1 **Andrew Dzambo, Dave Turner, Eli Mlawer**
2 **Replies to Interactive Comments on “Evaluation of two Vaisala RS92**
3 **radiosonde solar radiative dry bias correction algorithms”**

4
5 **March 10, 2016**

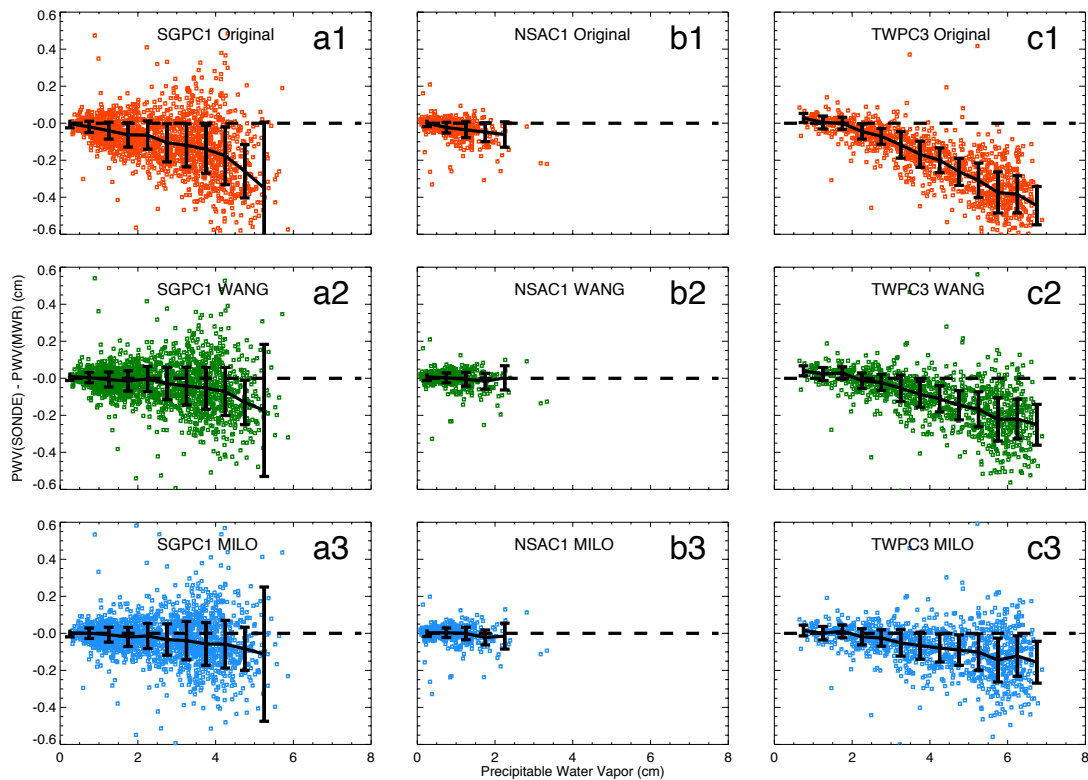
63 **P10760 L21: It doesn't seem logic to remove 20% of the data as outlier**

65 *We agree – as it turns out, this was a mistake we missed because we intended*
66 *to remove only 10% of the data total, such that the influence of outliers does not*
67 *manifest itself in Table 1 and Figure 1. Both Table 1 and Figure 3 have been updated*
68 *such that only 10% of the original data were removed, and the text has been modified*
69 *to reflect this change. While making this change, we found in the computer code that*
70 *an additional 10% of the data was removed by accident for the numbers shown in*
71 *Table 1 except for where the number of points are given (the values given in the*
72 *updated Table 1 and the old Table 1 for N = ... are correct).*

74 *Note that an additional change to Figure 3 was made – the y-axis label was*
75 *updated to correctly show PWV(sonde) – PWV (MWR). The new figure is reproduced*
below:

Figure 4: The water vapor Jacobian computed for mean conditions at Cerro Toco at the GVRP frequencies.

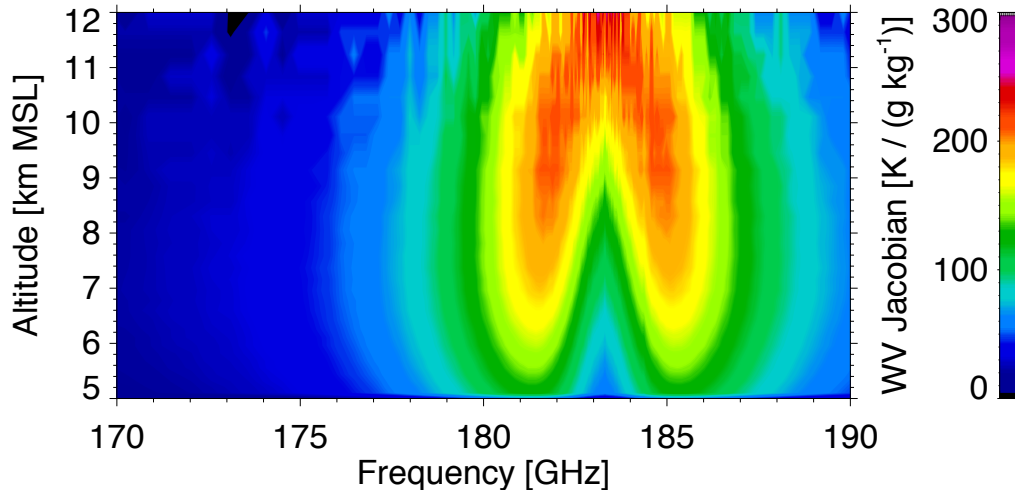
142
143 **Section 3: It would be good to see the Jacobians for the MW radiometer.**
144 **Unless, I am missing something, the authors have sim-interpreted the results**
145 **for the downwelling case.**

We added the WV Jacobian at the GVRP frequencies to the paper as Figure 4. The new figure and associated caption are reproduced here. The figure reference was inserted on p. 10762, L16.

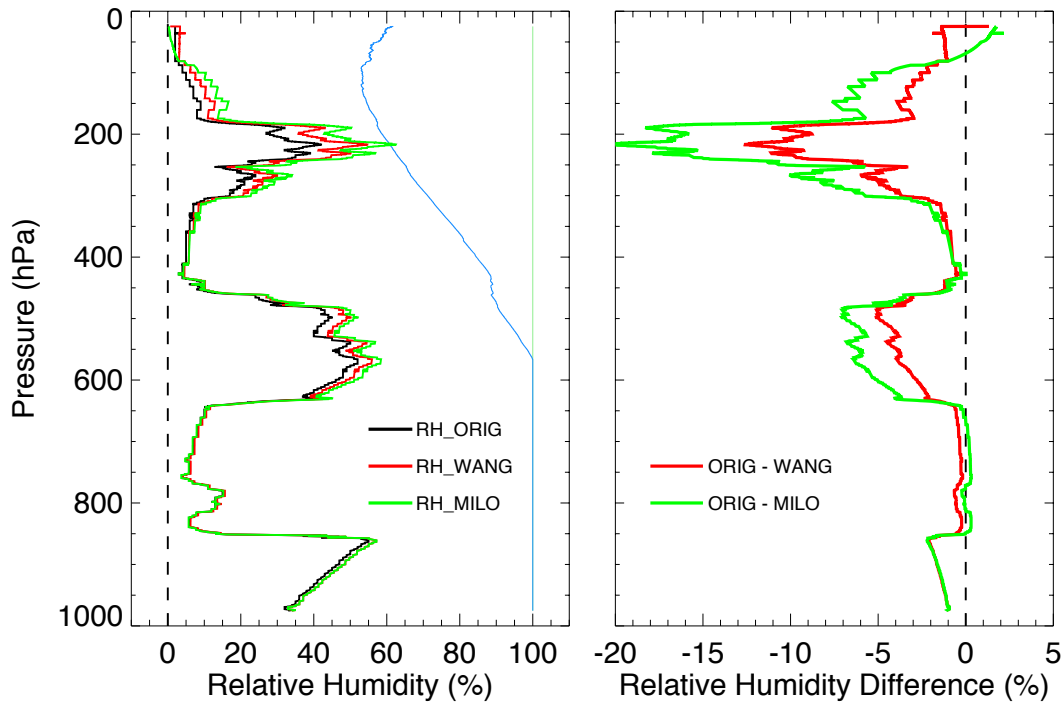
221 **Figure 1: it would be better to show ORIG -MILO and ORIG - WANG as it is very**
222 **hard to see the differences now**

223 *Figure 1 was intentionally presented this way to show how the differences in*
 224 *RH compare to the original RH profile, such that it visually emphasized that the actual*
 225 *changes in RH seem small or hard to discern. We do agree though that the numerical*
 226 *difference is hard to gauge, which could be valuable to the reader. Thus, we have*
 227 *updated Figure 1 to be a 2-panel plot: the left figure showing the baseline RH profiles*
 228 *(original RH profile and WANG/MILO corrected profiles) while the right figure shows*
 229 *ORIG – WANG and ORIG – MILO. The new figure is reproduced here (changes in figure*
 230 *caption are **bolded**):*
